Subject: **Docket Test Procedure for Battery Charger Systems;
2008 Rulemaking on Appliance Efficiency Regulations;
Docket No. 08-AAER-1B**

The Consumer Electronics Association (CEA) submits the following comments in response to the California Energy Commission's consideration of proposed test procedure for battery charger systems ("Energy Efficiency Battery Charger System Test Procedure" – Version 2.1.4, August 1, 2008).

Figure 1: Laptop categorized as a Category 3 Product with a detachable battery pack

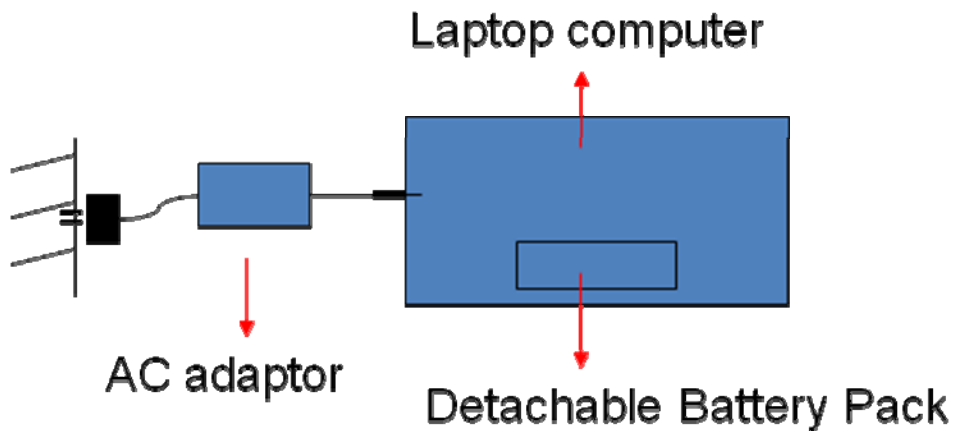
Conflict between “No-Battery Mode” definition and “Category 3 Products” description

Based the draft test procedure definitions of “No-Battery Mode” (on page 7) and “Category 3 Products,” it is unclear which power consumption should be measured for “no-battery power” as in the following laptop computer scenario:

The following diagram illustrates a measurement example:

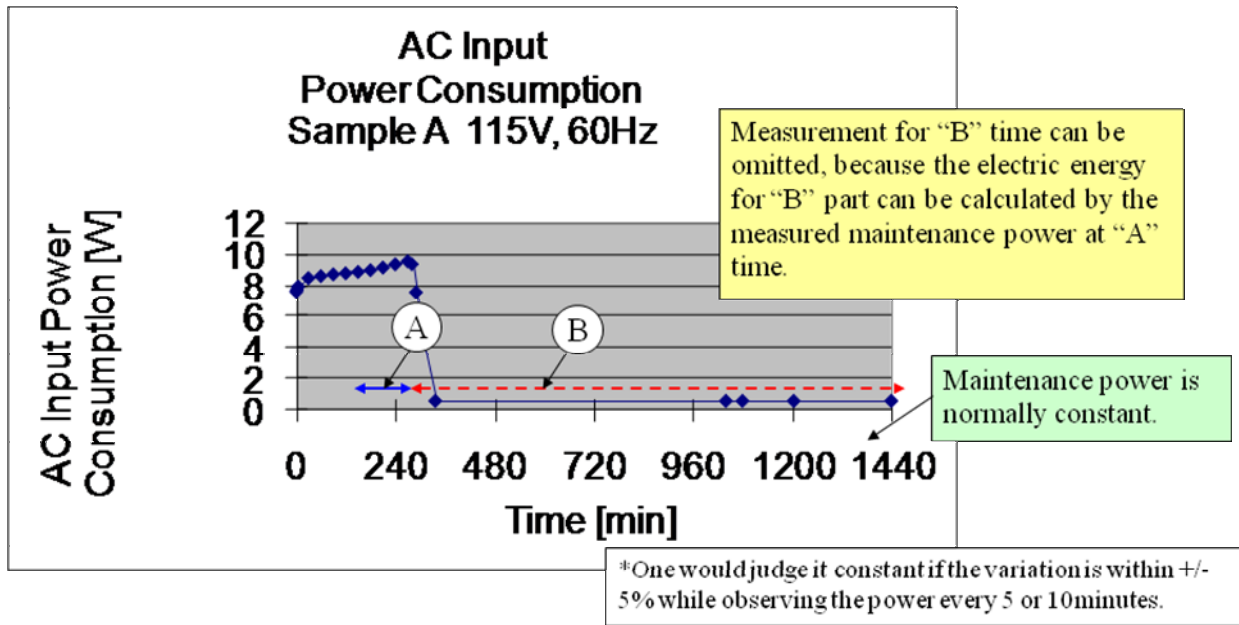
In order to save resources, reduce energy consumption and reduce testing costs, the measurement time for the “Charge Mode and the Battery Maintenance Mode Test” must be shortened. As currently drafted, the test procedure requires UUT measurement for at least 24 hours.

Based on member feedback, CEA requests that the following text be inserted as a new paragraph on page 18 following the paragraph which ends with “power over the measurement period and this result shall be used as the total energy”:

“If, during this test, the technician notices that the measured power becomes constant, the technician can stop this test and estimate the power consumption using the following formula:

If the maintenance power is constant(*) for one hour or more, then the maintenance power after that period can be judged constant, and the value as calculated by the following formula can be used as the electric energy (Ea) which is consumed for 24 hours on charge and maintenance mode.

Ea = “Measurement value (until stopping the measurement) of electric energy consumed on charge and maintenance mode” + “the maintenance power (average value measuring for 1 hour or more)” x “remaining time until 24 hours pass”
